TOWN OF FAIRFAX

Permit #20-T-09

NOTICE OF TREE COMMITTEE ACTION

PEOPLES RESIDENCE

PEOPLES RESIDENCE
63 SPRING LANE
FROM SHEET C3

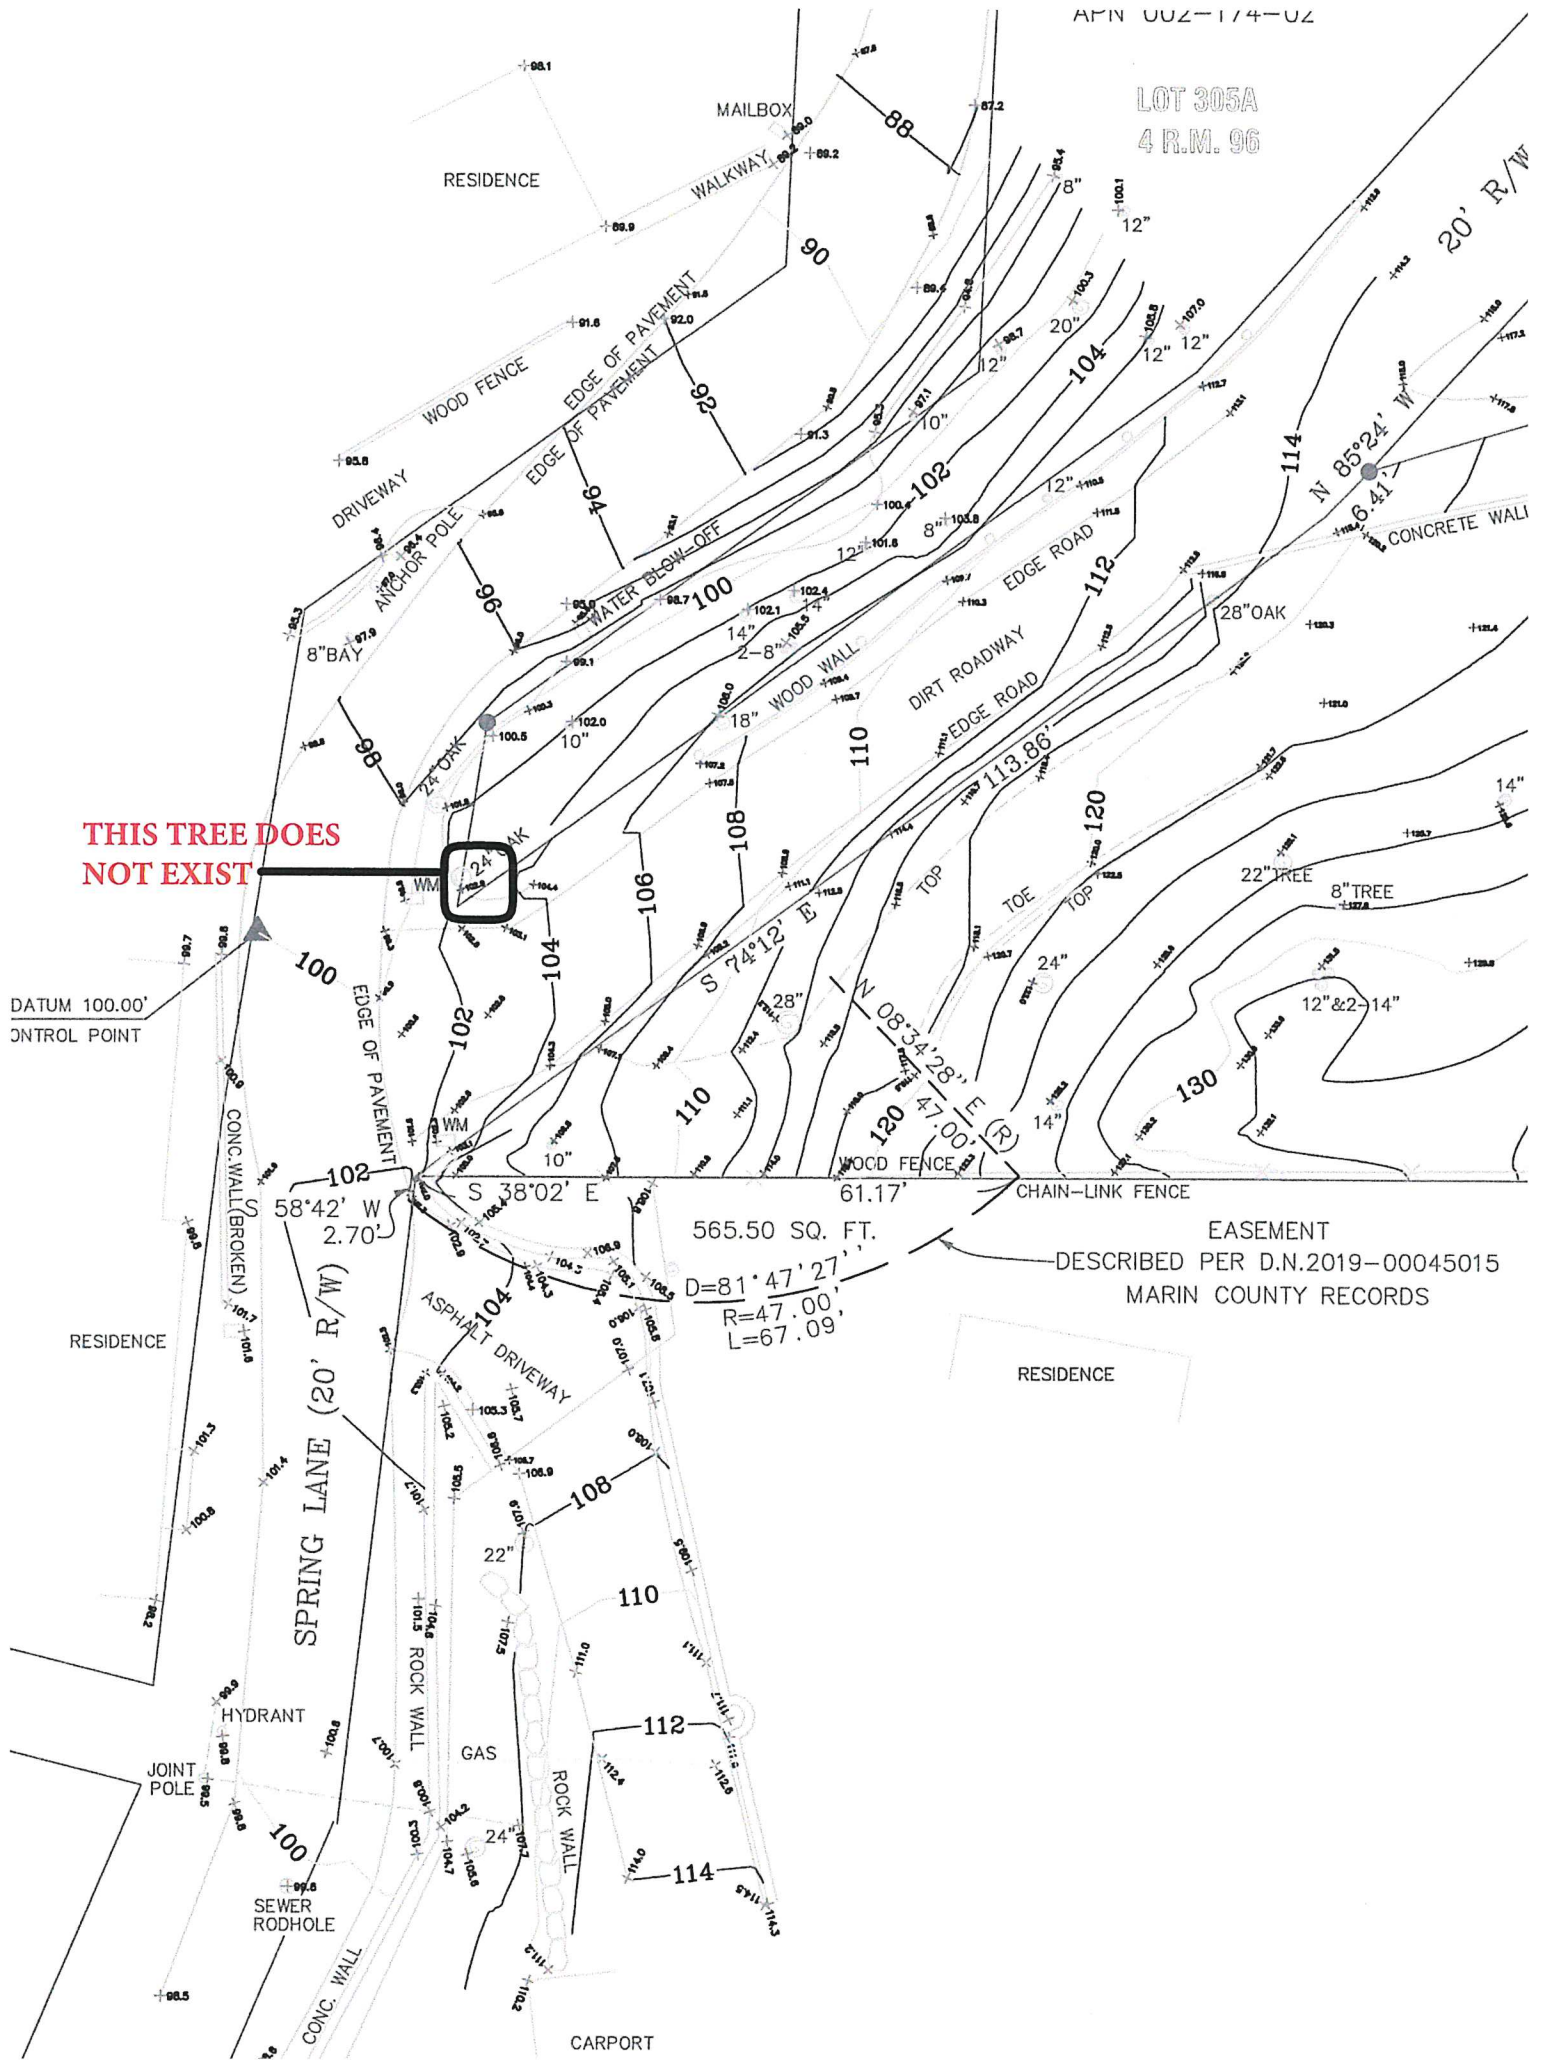
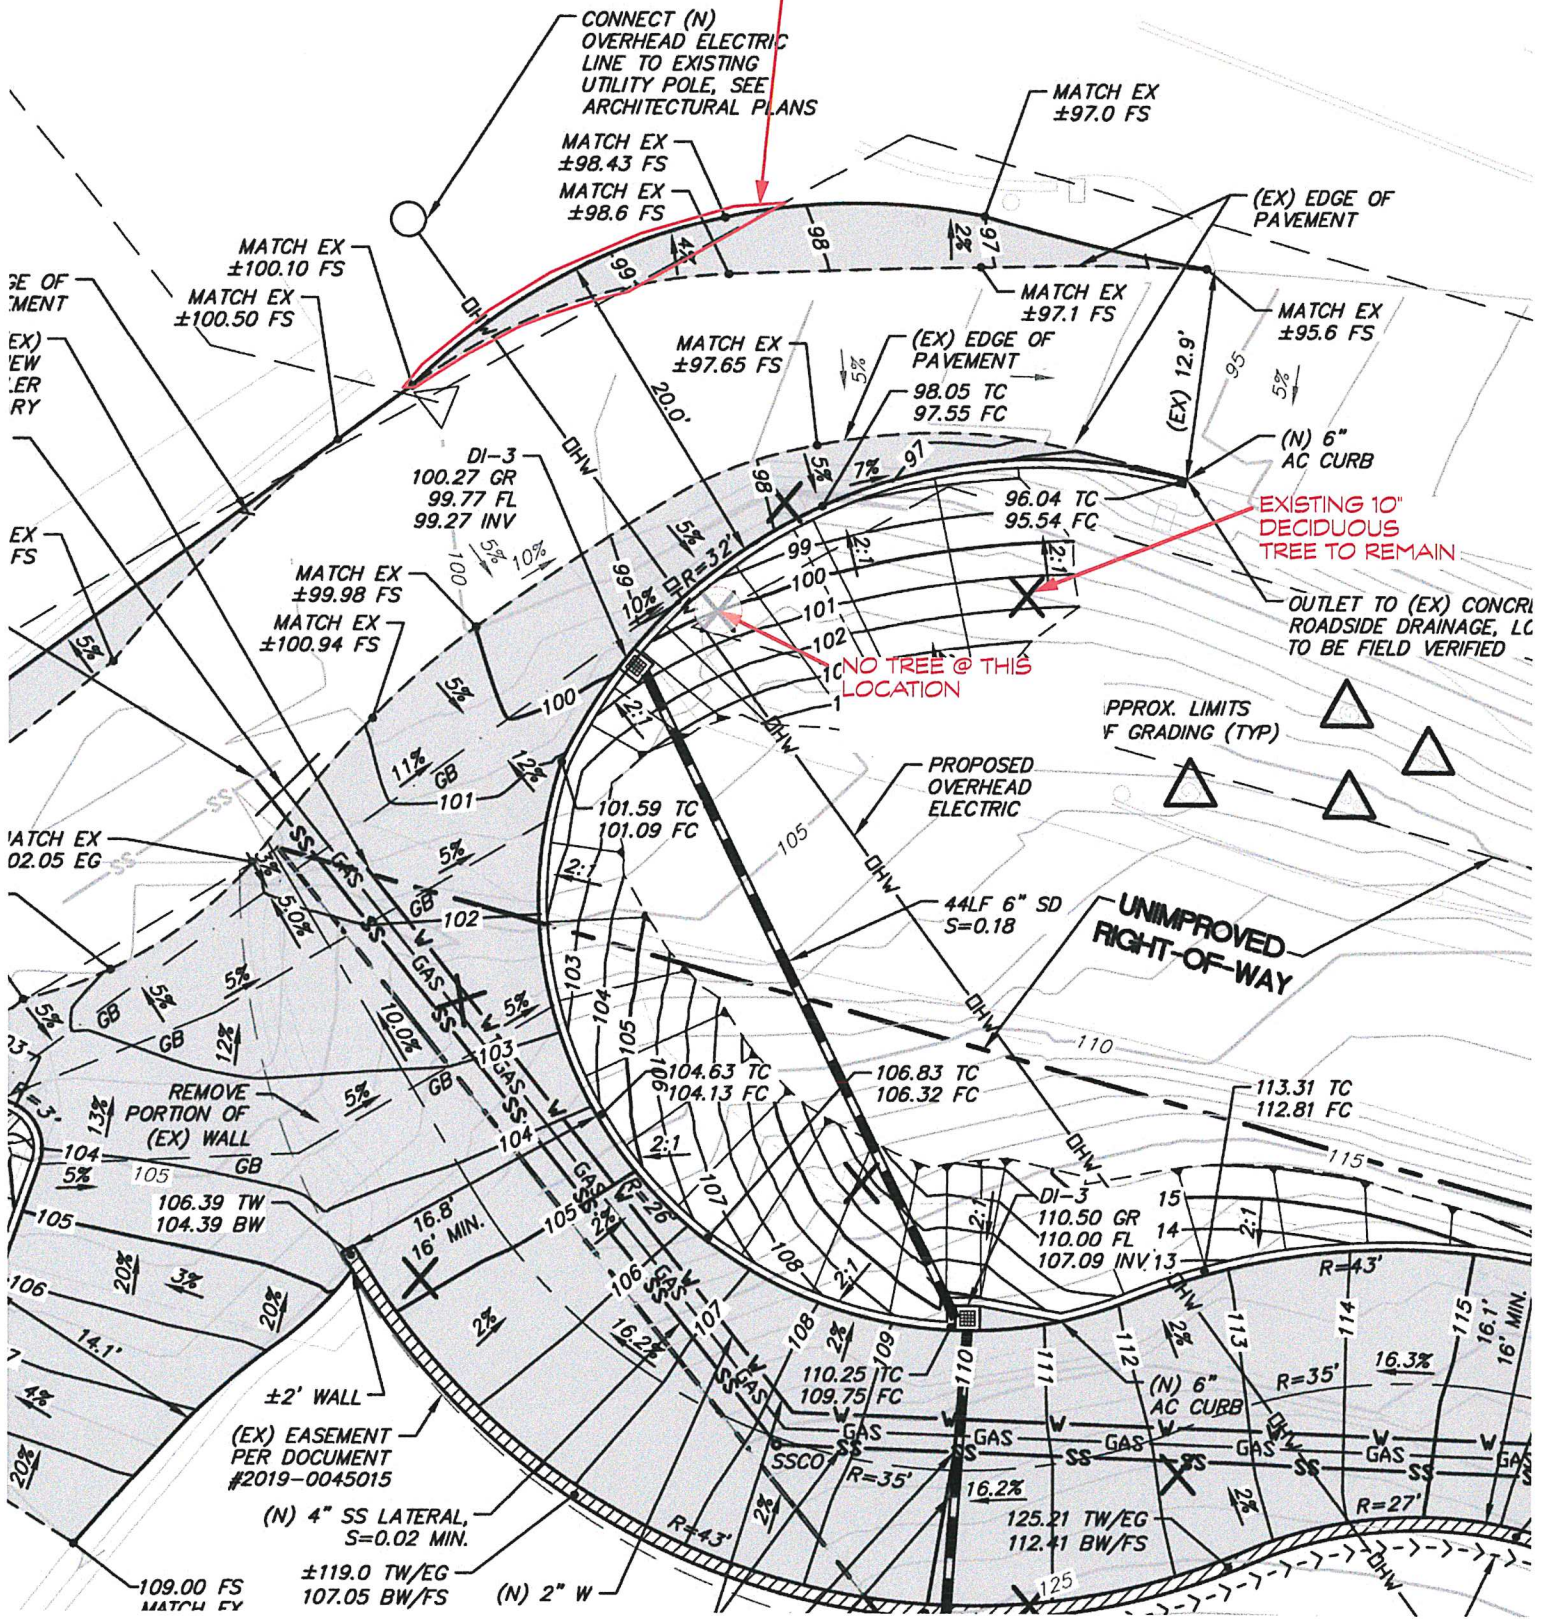
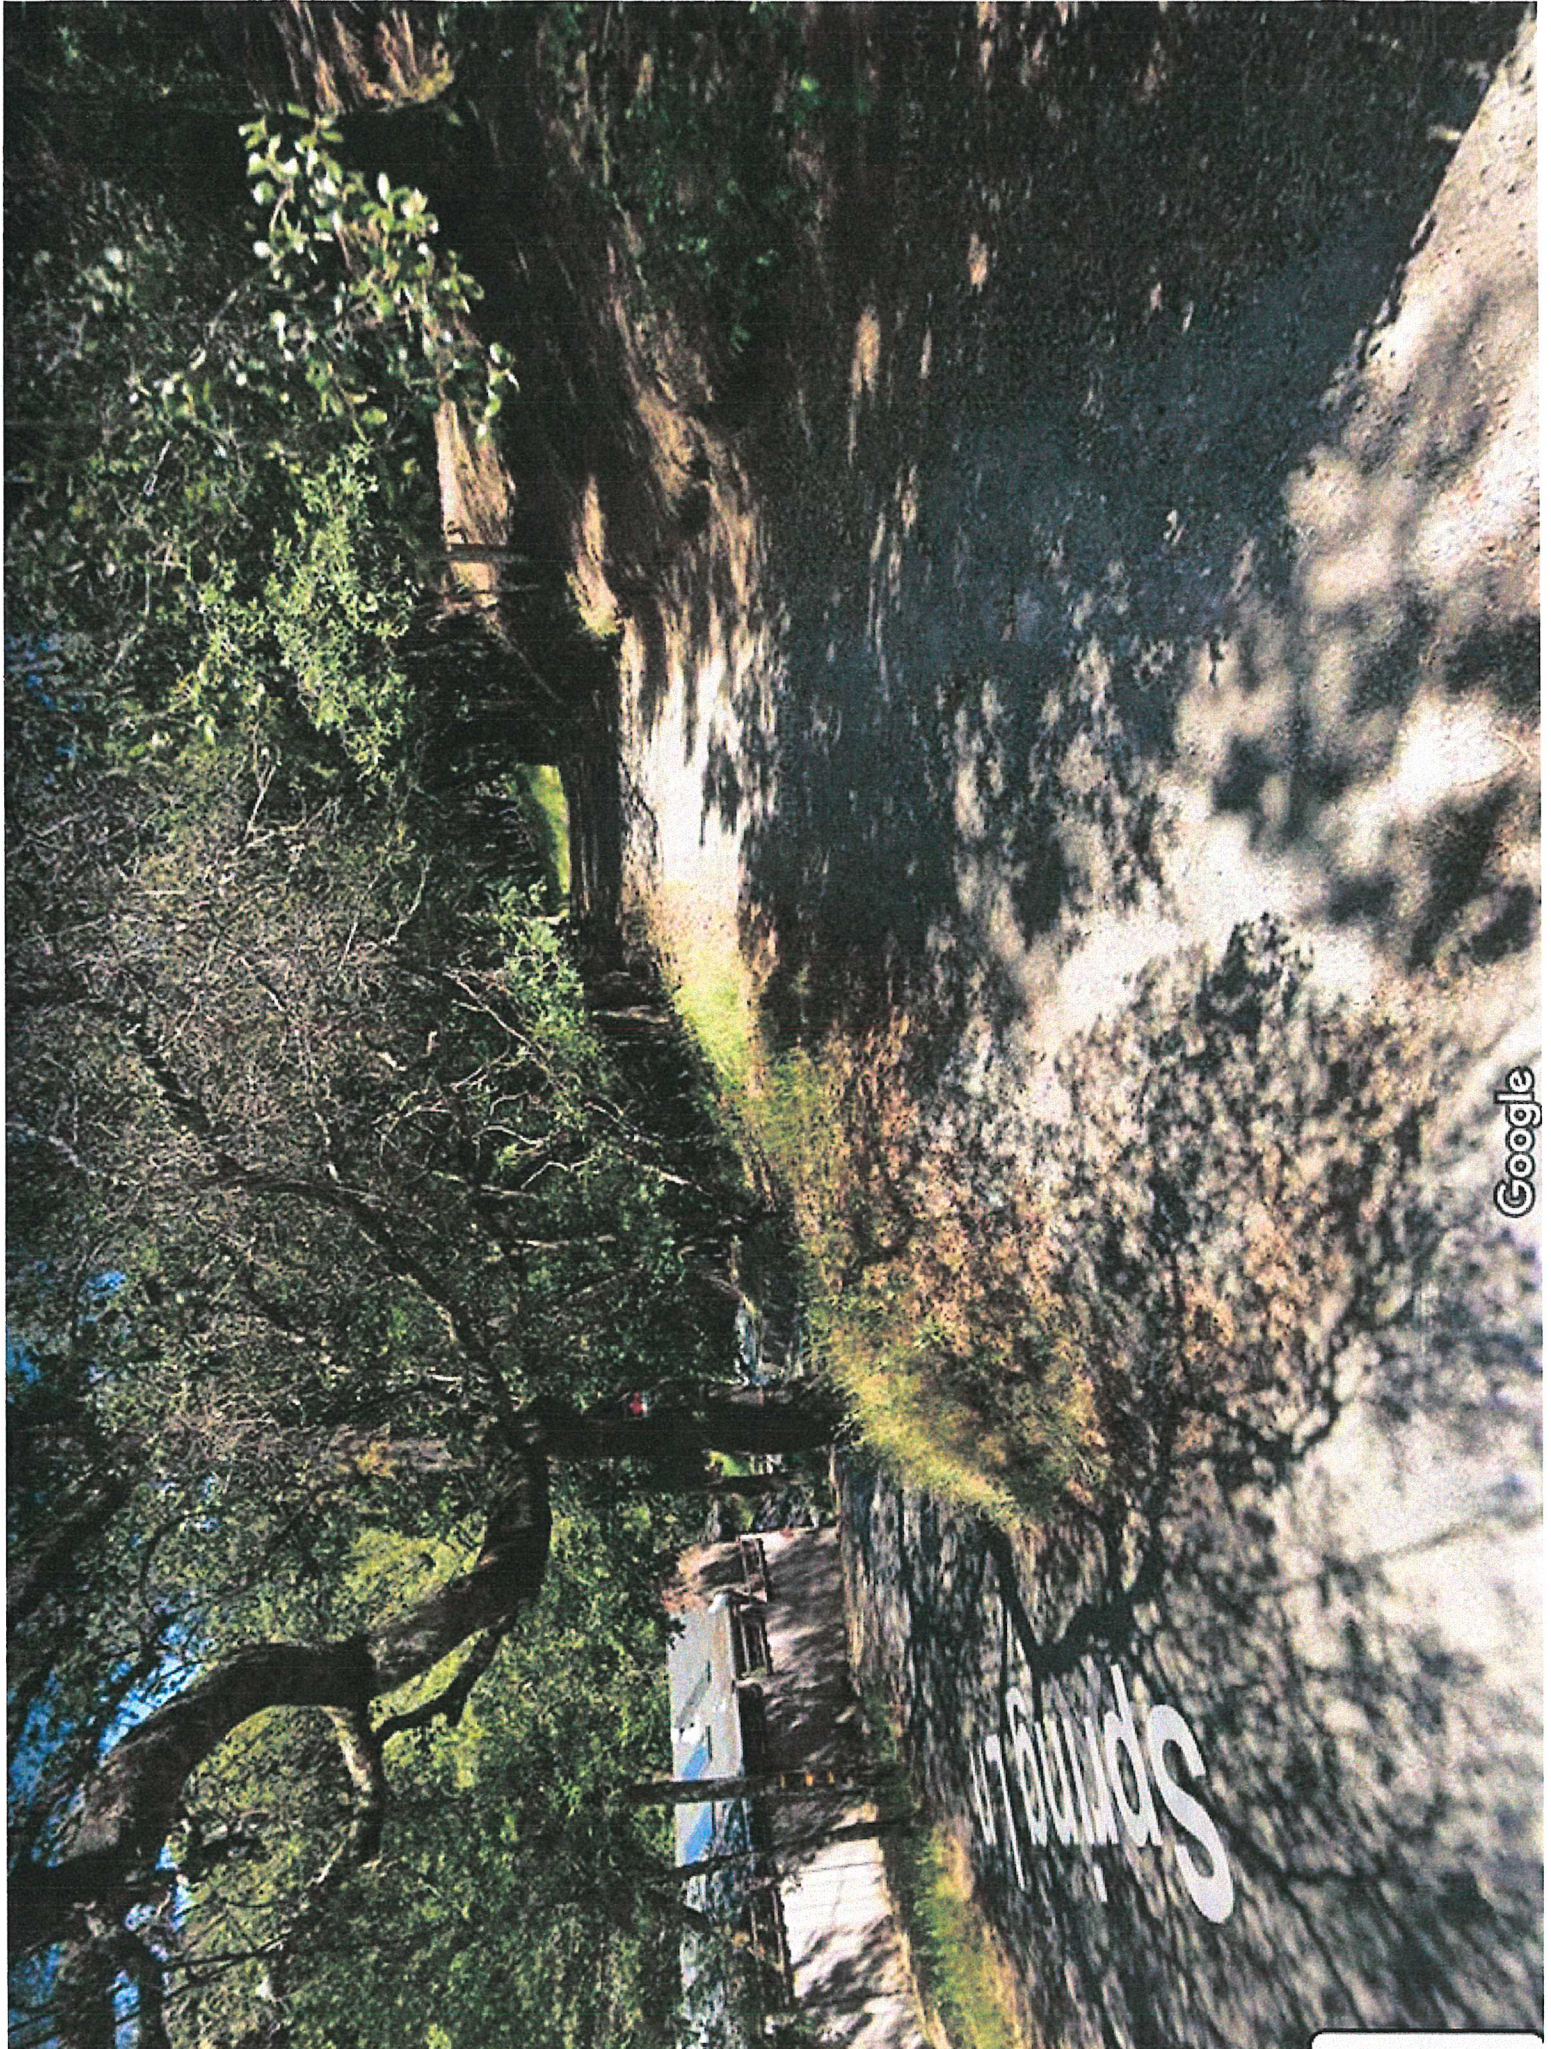
Please accept this clarification and correction to address the concern about tree removal on the adjacent property owner parcel.

We made a field inspection and found that there is only a single oak tree that needs to be removed due to the driveway construction. It is the tree that sits entirely in the Spring Lane right-of-way.

We checked our photos, review the google street view and then confirmed with a site visit and found that the 2nd tree shown on the survey as straddling the property line does not exist.

There is only one oak tree and it is at the edge of pavement well into the Spring Lane right of way.

The other tree in the neighbor's lot is a small deciduous tree and upon more review with the civil engineer does not need to be removed. We will coordinate with the neighbor and the civil engineer as the construction/permit drawings are developed if there is a change in the need to remove the tree and if so, will provide the neighbor's approval with the building permit application package.
